**MONTHLY REPORT 20 / August 2021**  
**for**  
**COSMOPOLIS PROJECT - ROMANIA**

## ANNEX 1

### Site Photos and Notes for August 2021

Q12:

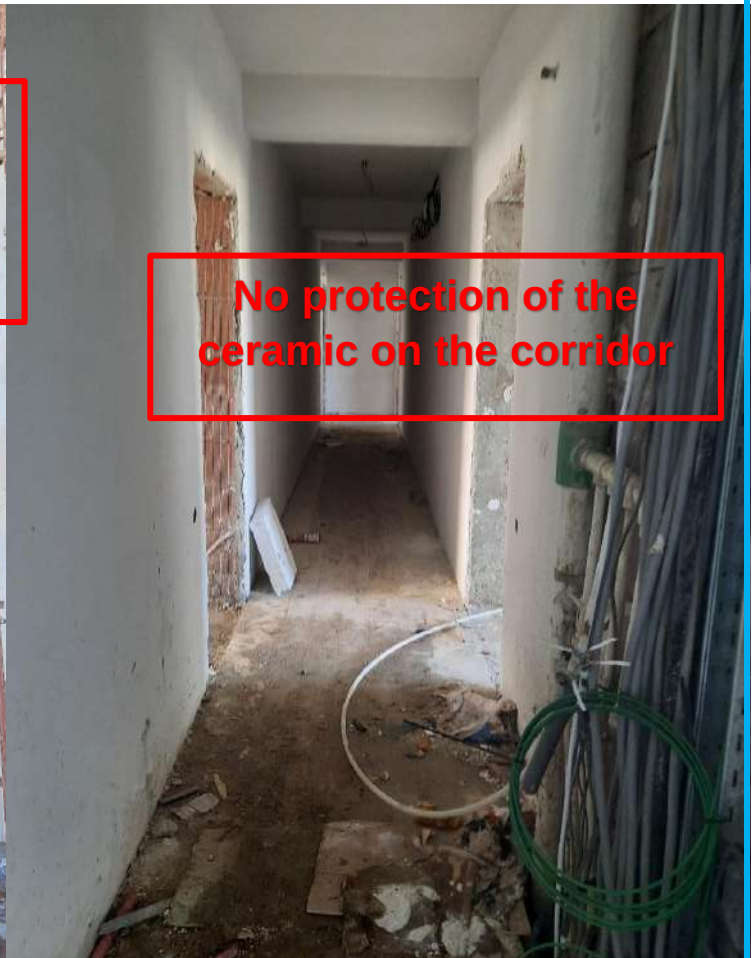
**Missing scaffold mesh,  
cleaning needed for  
safety reasons**

**Risk of accidents  
entering the building,  
scaffold with missing  
elements**

**No protection of the  
ceramic on the corridor**

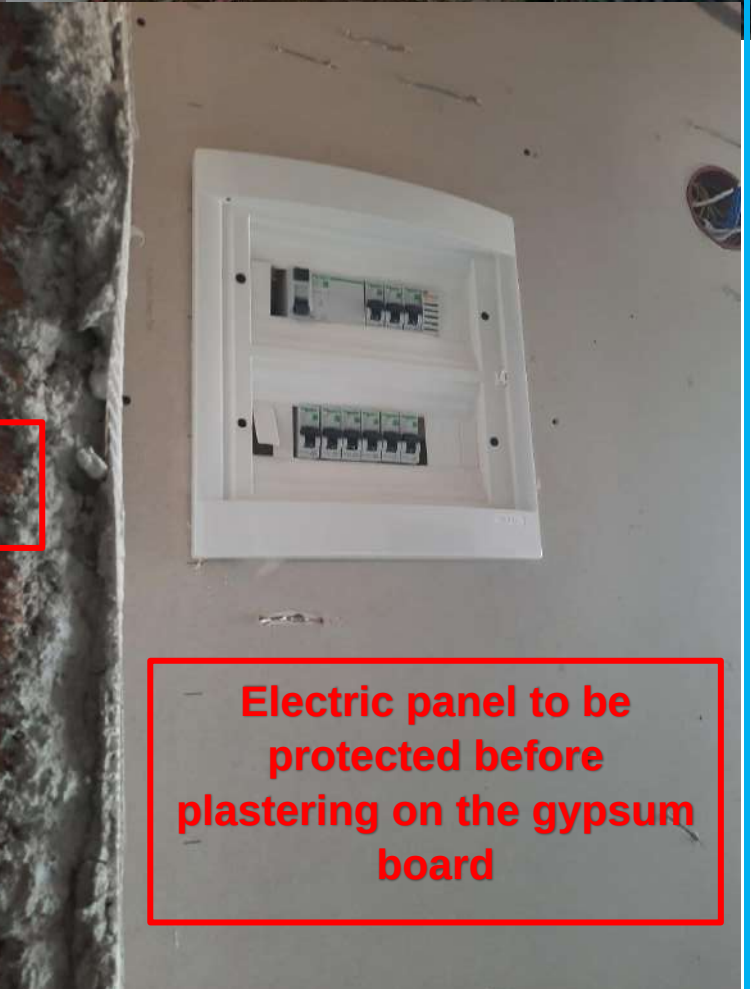
**No safety balustrade –  
risk of falling**

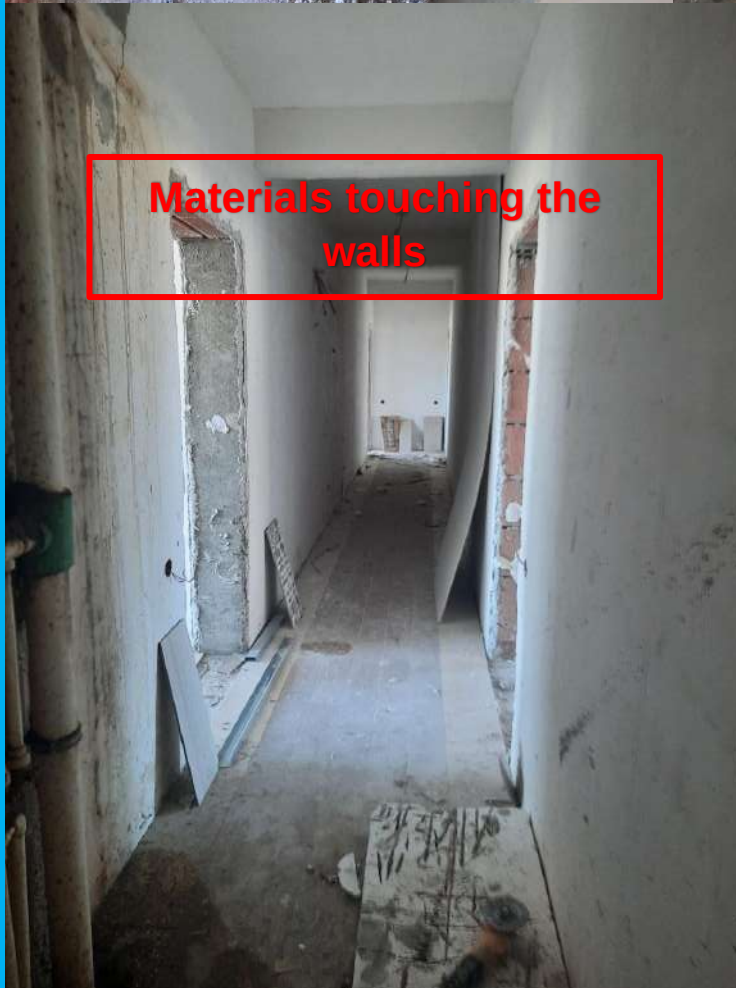
**Electric panel to be  
protected before  
plastering on the gypsum  
board**

## Q15: Exterior view

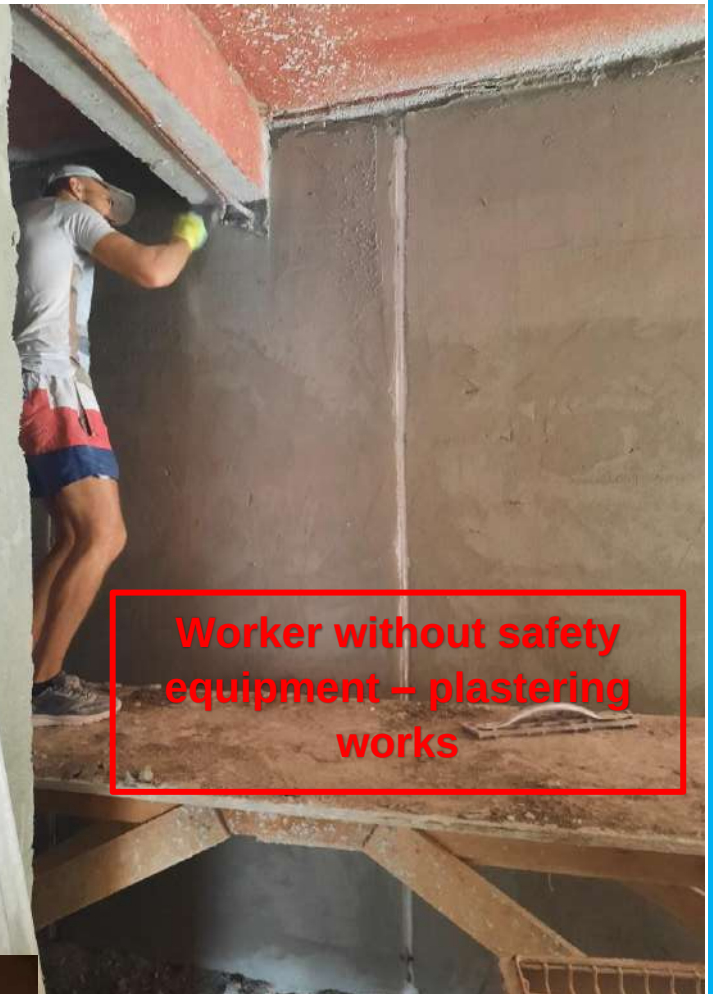
**Exterior cleaning needed**

**Worker without safety equipment – plastering works**

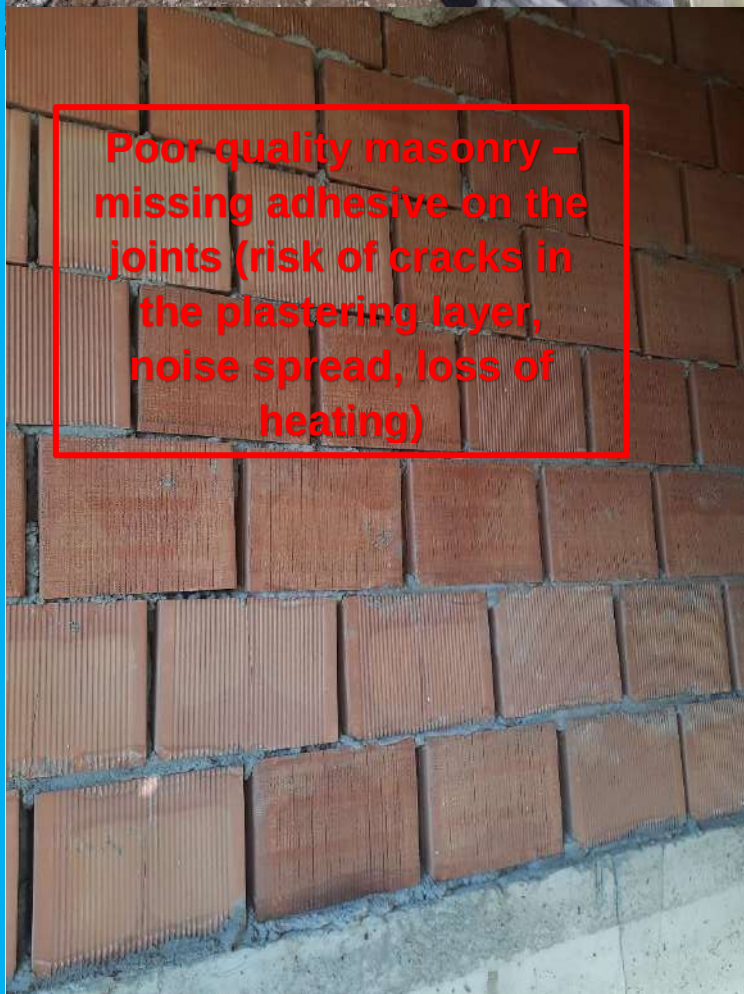
**Poor quality masonry – missing adhesive on the joints (risk of cracks in the plastering layer, noise spread, loss of heating)**
